Plan Change Request

Site Address/ Parcel #: 325 Todd Road NW Permit #: PRCCP20240215
Owner: Puyallup Training Property, LLC c/o Trammell Crow Company Email: cmcgeever@trammellcrow.com
Design Engineer: Chris Bicket Email: bicket@tenw.com
Contractor: Pennon Construction Email: jacobb@pennonconstruction.com

➤ Specify the approved civil plans affected: IL-01 THRU IL-03

ILLUMINATION PLAN

DRAWING NO.:
IL-01

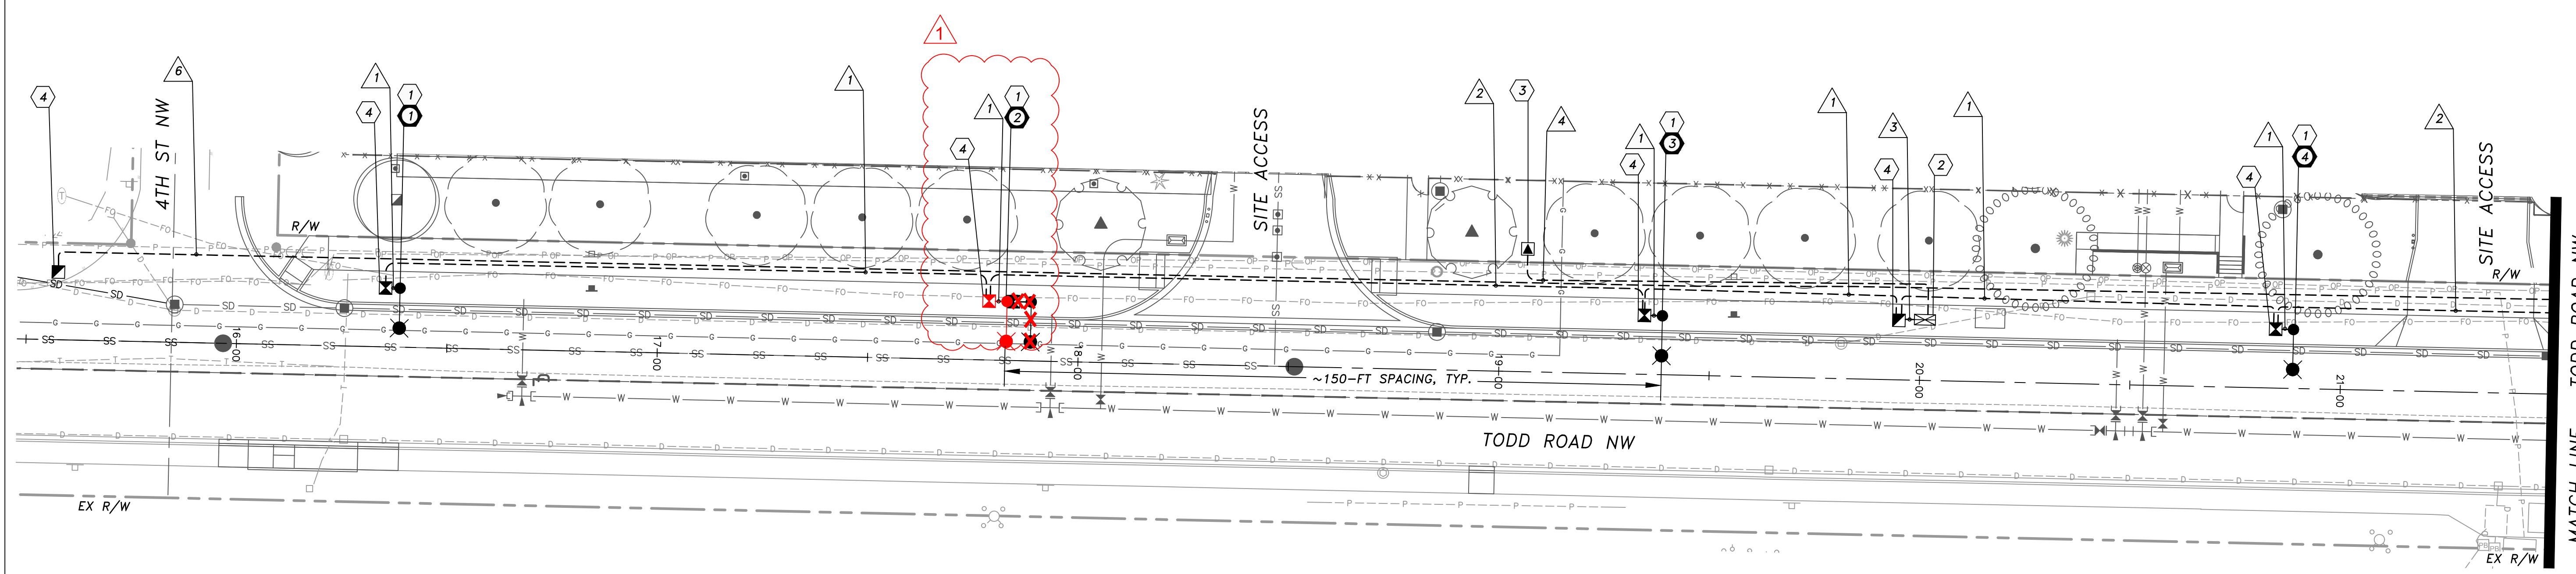
➤ Describe the change(s) being requested:
Light Pole #2 shifted approximately 6-ft West to maintain clearance from fire hydrant.
Light Pole #8 was shifted approximately 5-ft West to maintain clearance from power pole.
Added new conduit & junction box to connect existing PSE light pole to new City owned illumination system as requested by the City.

REVISION	DATE	BY
1 LUMINAIRE POLE SHIFTS & CONDUIT REVISIONS	03-14-25	BVL

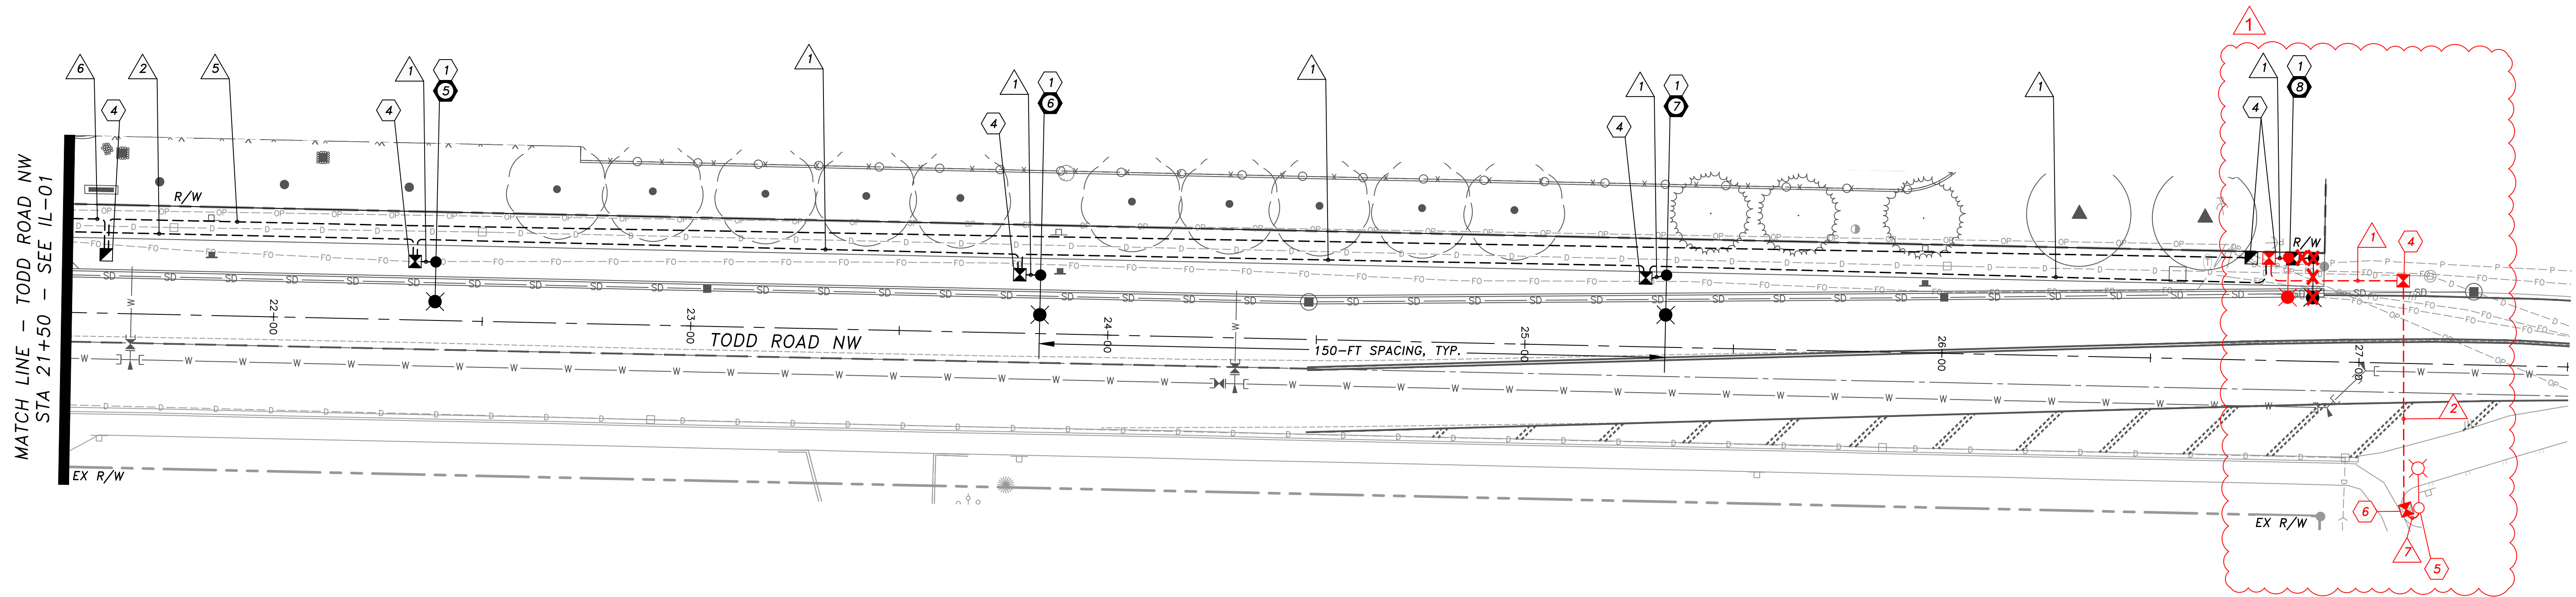
<table border="1"> <thead> <tr> <th>REVISION</th> <th>DATE</th> <th>BY</th> </tr> </thead> <tbody> <tr> <td>1 LUMINAIRE POLE SHIFTS & CONDUIT REVISIONS</td> <td>03-14-25</td> <td>BVL</td> </tr> </tbody> </table>	REVISION	DATE	BY	1 LUMINAIRE POLE SHIFTS & CONDUIT REVISIONS	03-14-25	BVL	DESIGNED BY: DAG DRAWN BY: BVL APPROVED BY: CTB	ISSUE DATE: 08-05-2024 JOB NO.: TENW #2022-380 DRAWING FILE NO.:		<p align="center">TENW Transportation Engineering NorthWest 11400 SE 8th Street, Suite 200, Bellevue, WA 98004 Office (425) 899-6747 Project Contact: Brenda Velazquez Lopez Phone: 206-773-5386</p>	<p align="center">TC NORTHWEST DEVELOPMENT INC 600 UNIVERSITY STREET SUITE 2912 SEATTLE, WA 98101 CDOBBS@TRAMMELLCROW.COM CRAIG DOBBS</p>	<p align="center">PSE TODD ROAD OTC</p> <p align="center">ILLUMINATION PLAN</p>	DRAWING NO.: IL-02
	REVISION	DATE	BY										
1 LUMINAIRE POLE SHIFTS & CONDUIT REVISIONS	03-14-25	BVL											
SHEET NO.: 2 OF 4 SHEETS

DRAWING NO.:
IL-03

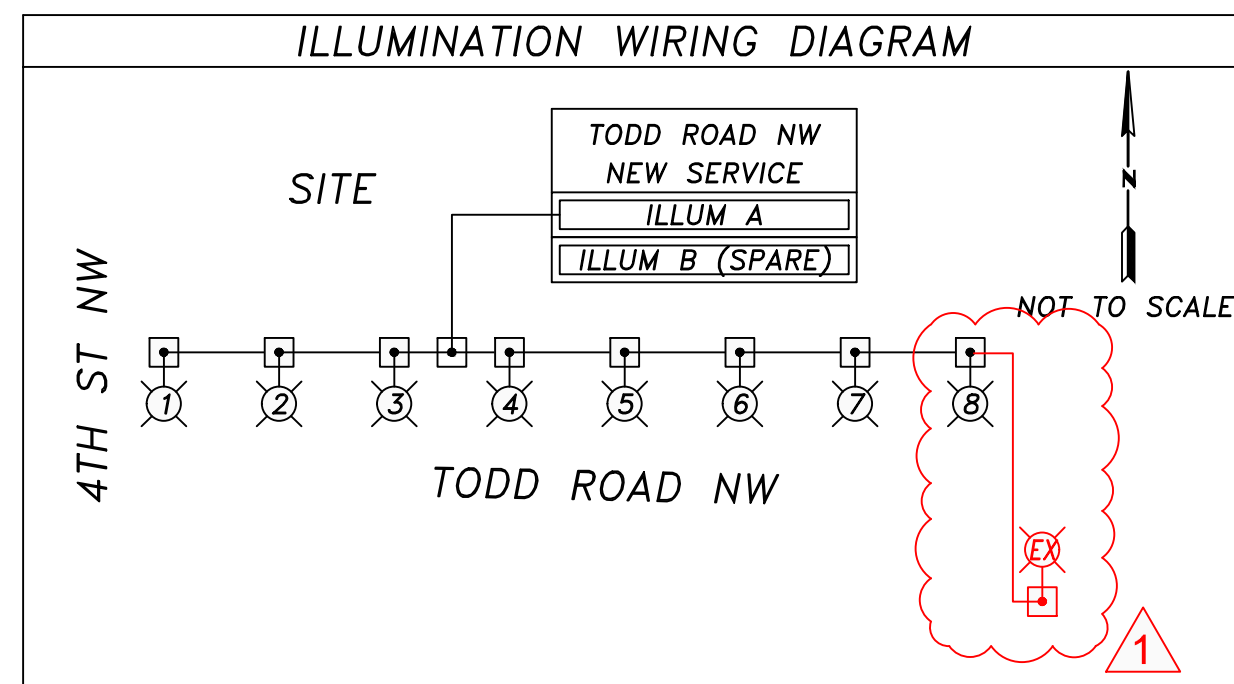
REVISION	DATE	BY
1 LUMINAIRE POLE SHIFTS & CONDUIT REVISIONS	03-14-25	BVL
